# Municipality of Brockton Planning Report

**To:** Municipality of Brockton Council  
**From:** Dana Kieffer, Planner  
**Date:** January 21, 2020  
**Applications:** Re-zoning from R1 to R2 Special with Holding  
**Files:** Z-44-19.36 care of 2369906 Ontario Ltd. (agent: Steve Cobean)

**Subject: Preliminary Stormwater Management Review  
Proposed Crawford Street Townhouse Development  
Municipality of Brockton  
O/Ref.: 02003**

# Site Plan

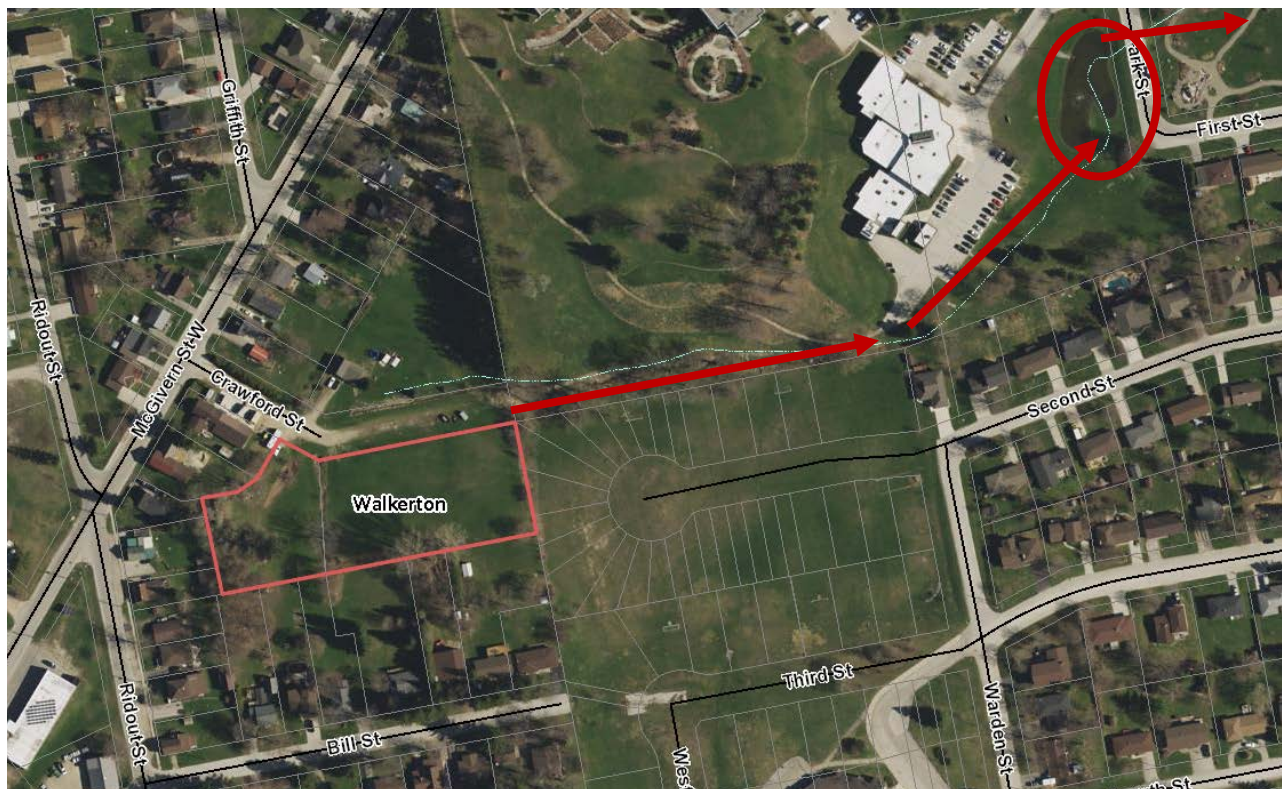
5. It appears as though the Cul-de-sac may encroach on adjoining properties – the Municipality of Brockton will need confirmation that the cul-de-sac is entirely on the applicant's property, or is there a plan to sever and transfer portions of those adjacent properties to the applicants for the cul-de-sac?

6. The Applicant will need to specify the type of structure being proposed for the small boxes on the end of each unit. Depending on the proposal, these structures may not comply with the required setbacks.

Dwg. 02003-STM3 attached shows the location of the proposed chamber systems.

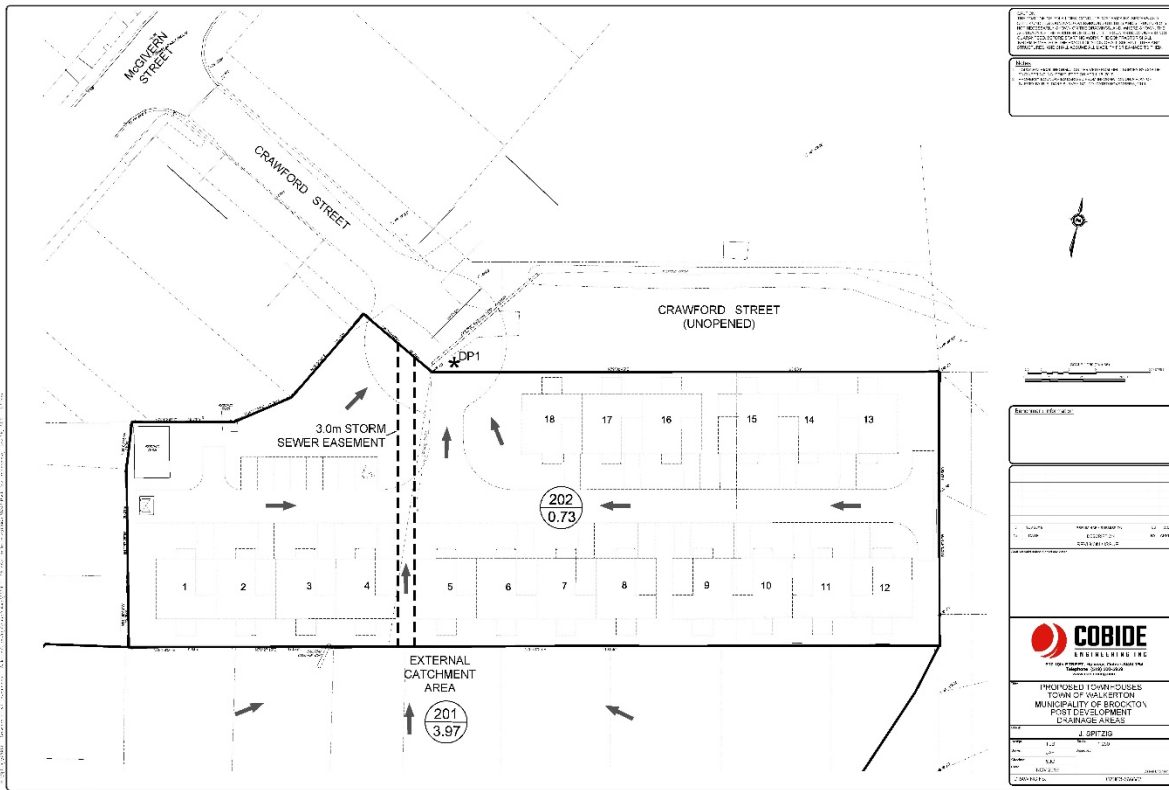
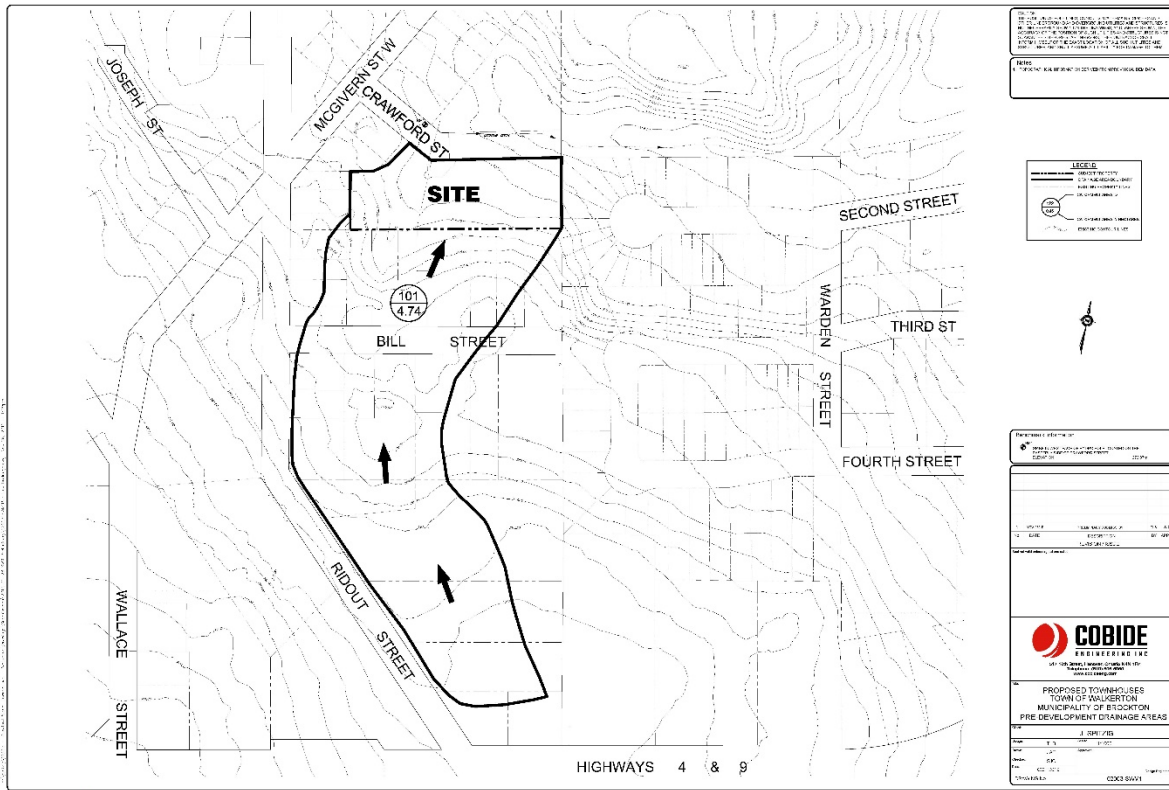
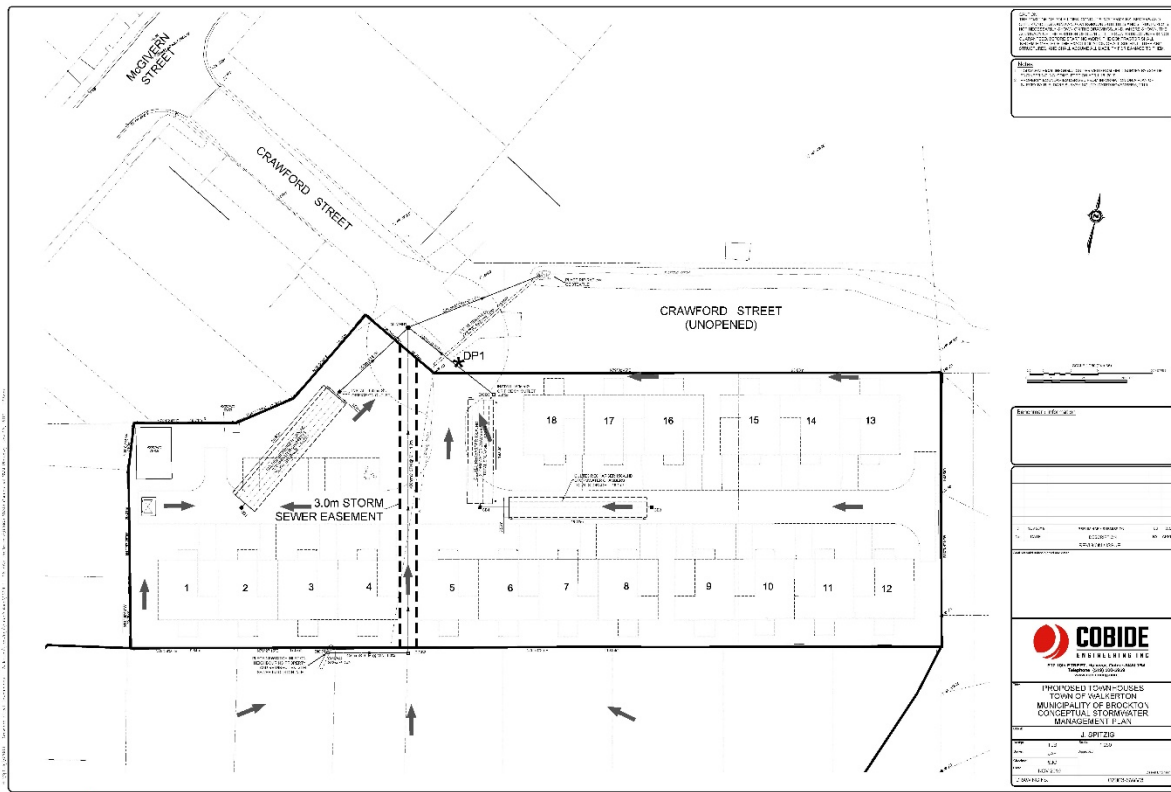
1. The submission is a Preliminary SWM report; without servicing and grading plans being submitted our comments are limited to the following to generalities.

2. The stormwater modelling looks reasonable.
3. Stormwater quantity control is proposed to be handled with sub surface storage. Final drawings detailing the storage and utility locations will need to be reviewed.

4. The preliminary design proposes to direct both the minor and major flow to the County ponds.
5. Should there be a review to see if the grade on Crawford Street can be raised sufficiently to direct major storm by surface flow to McGivern Street rather than easterly to the County pond?

6. If the County pond is to be the outlet for the minor and the major storm flows from the proposed development, a municipal drainage easement should now be established between the end of Crawford Street and the County pond and all flows contained by whatever conveyance means is proposed.

7. If flows are to be directed to the County pond it will need to be confirmed that the pond and its control features are not impacted negatively.
8. Crawford St should be constructed to municipal standards. It is noted that the house that fronts on the south side of Crawford appears to have a significant encroachment of drives and parking into the road allowance.

2. The current plan has some stormwater infrastructure located on adjacent properties with no easements. This infrastructure will need to be located on the applicant's property with the corresponding easements to the Municipality for maintenance.

4. As the Bruce county stormwater management pond is being proposed as an outlet, a municipal easement between the end of Crawford Street and the County pond will be required as per the Municipal Engineer's recommendations.

It appears that the Preliminary Stormwater Management Report does not address stormwater quality treatment. Therefore, SVCA staff recommend that stormwater quality

treatment be addressed, and we further recommend that enhanced stormwater quality treatment be implemented as per SVCA's attached Stormwater Management Criteria (stormwater quality treatment highlighted for ease of reference).
